DRAINAGE CALCULATIONS - SOUTH SIDE PONDING (BACKYARDS ONLY)

DRAINAGE CERTIFICATION

CITY OF ALBUQUERQUE
PUBLIC WORKS DEPARTMENT

GRADING PLAN

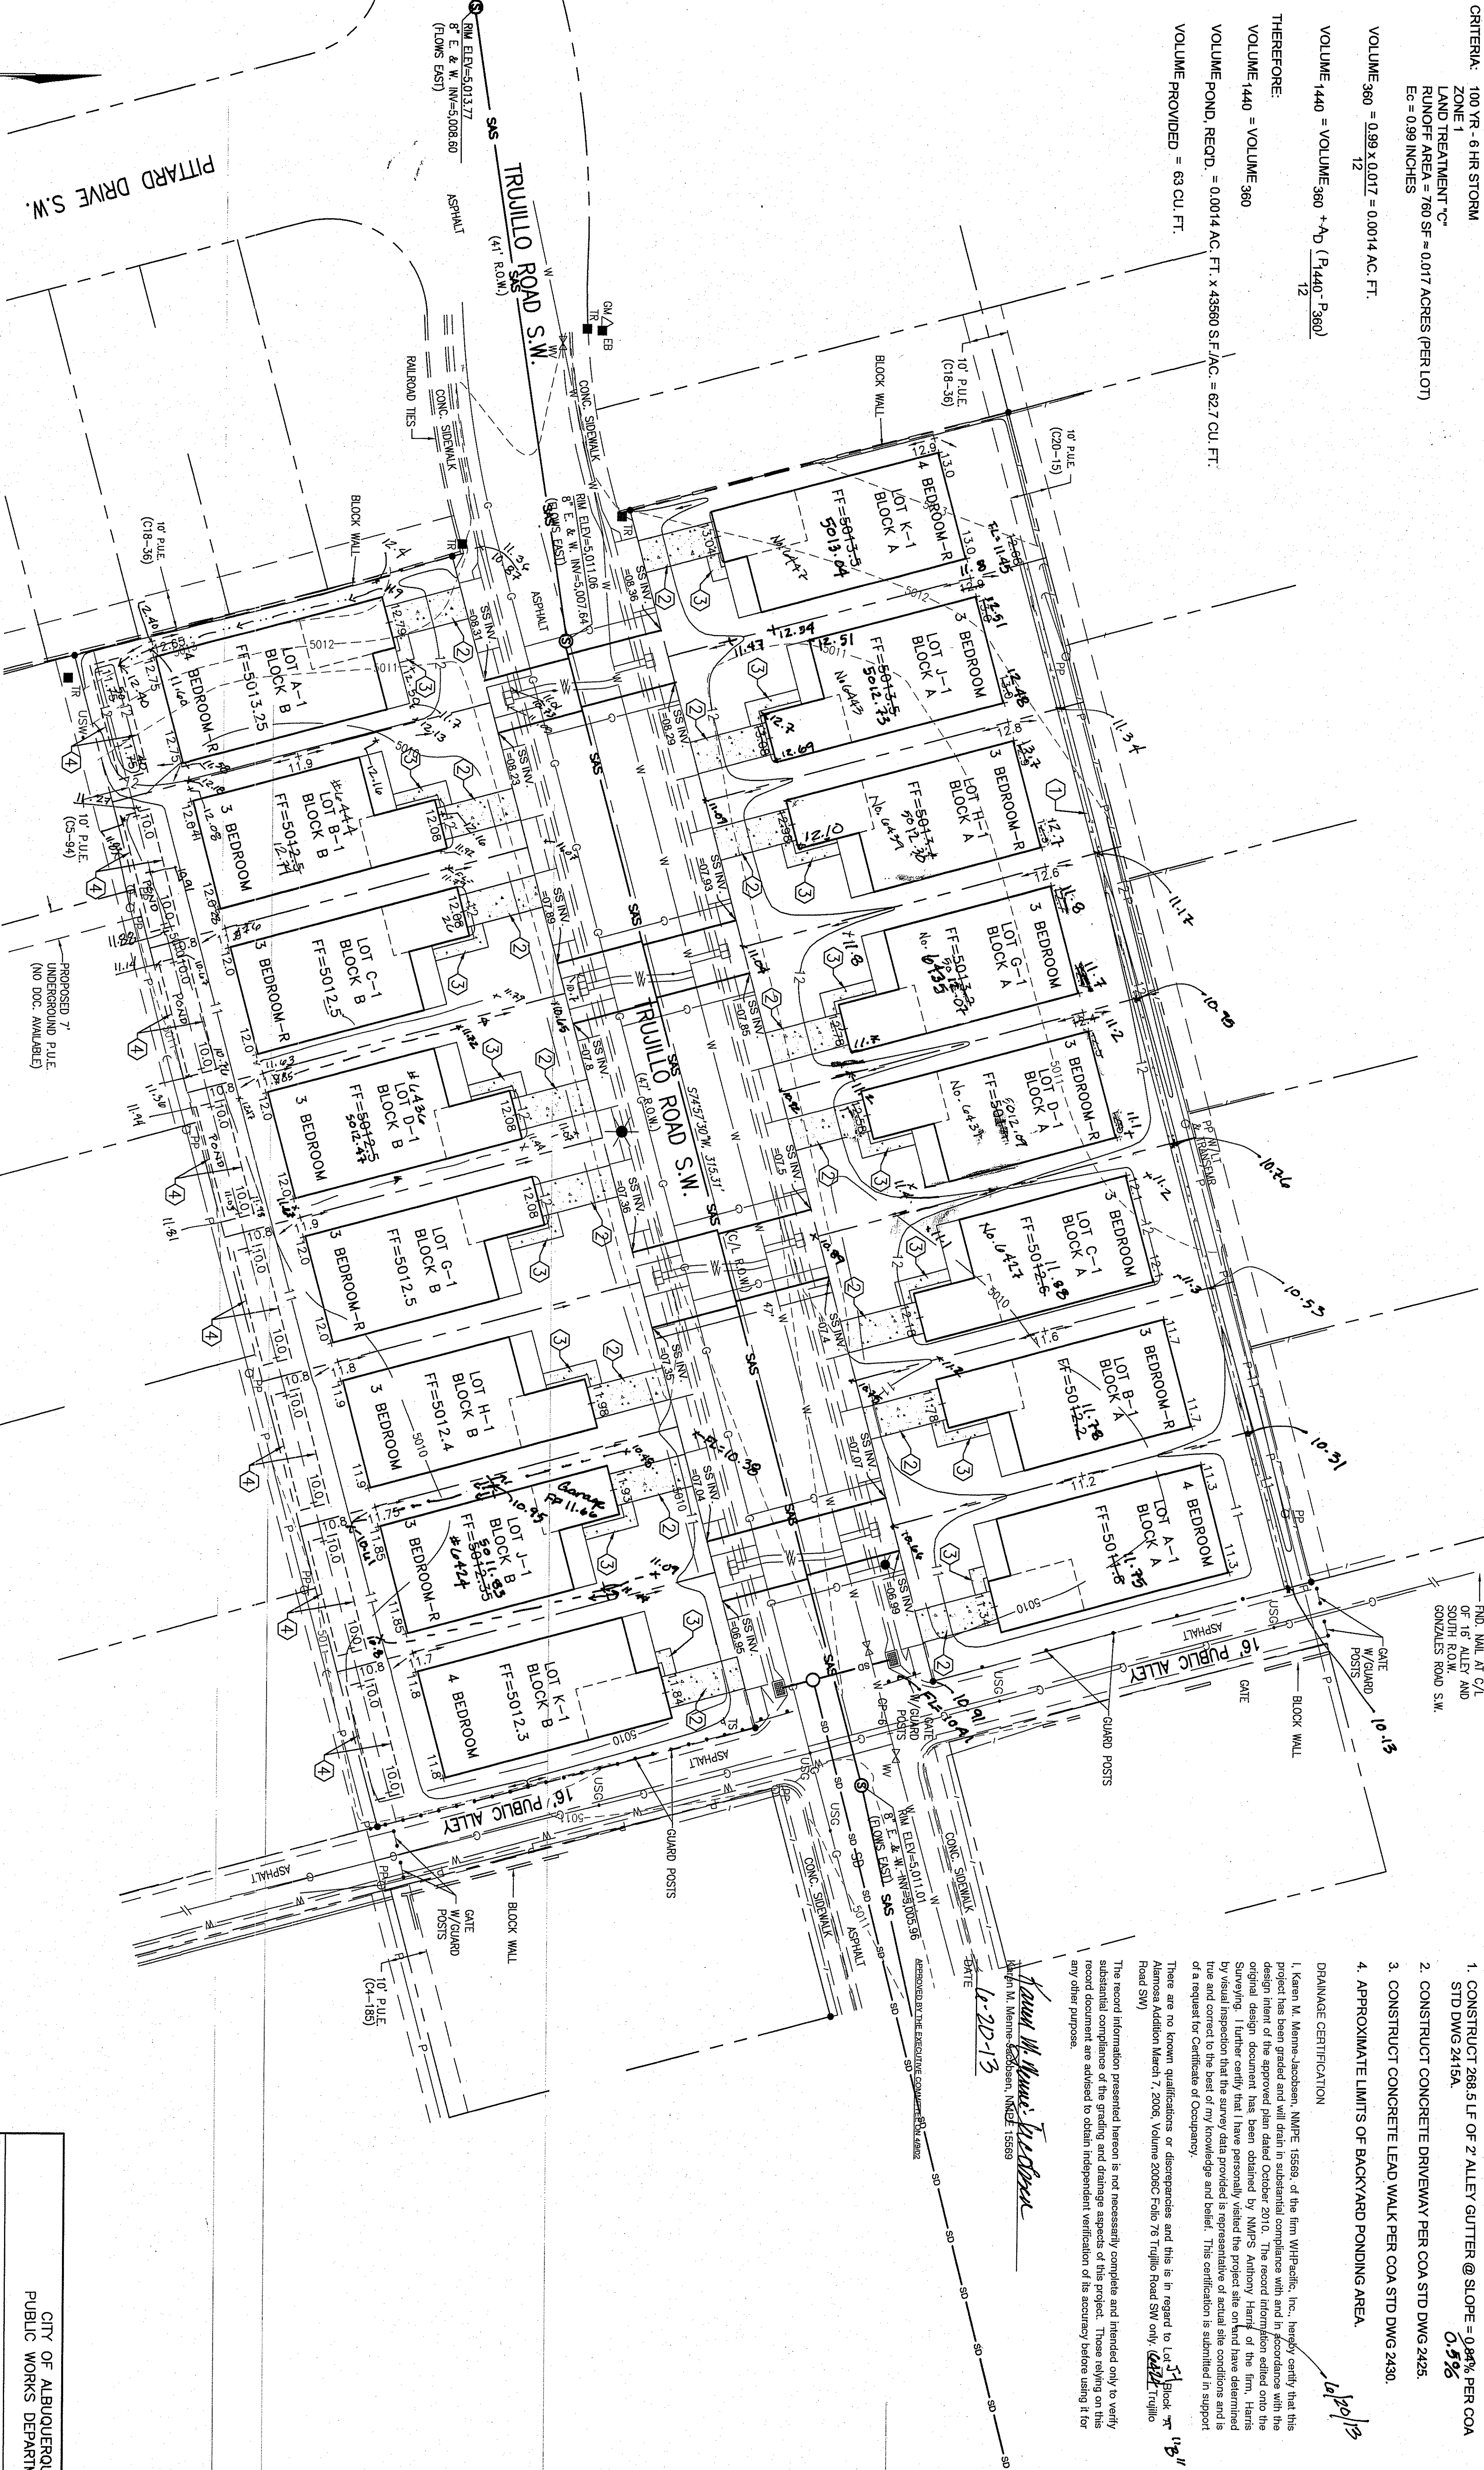
- CONSTRUCT 268.5 LF OF 2' ALLEY GUTTER @ SLOPE = 0.84% PER COA STD DWG 2415A. **0.9%**
- CONSTRUCT CONCRETE DRIVEWAY PER COA STD DWG 2425.
- CONSTRUCT CONCRETE LEAD WALK PER COA STD DWG 2430.
- APPROXIMATE LIMITS OF BACKYARD PONDING AREA.
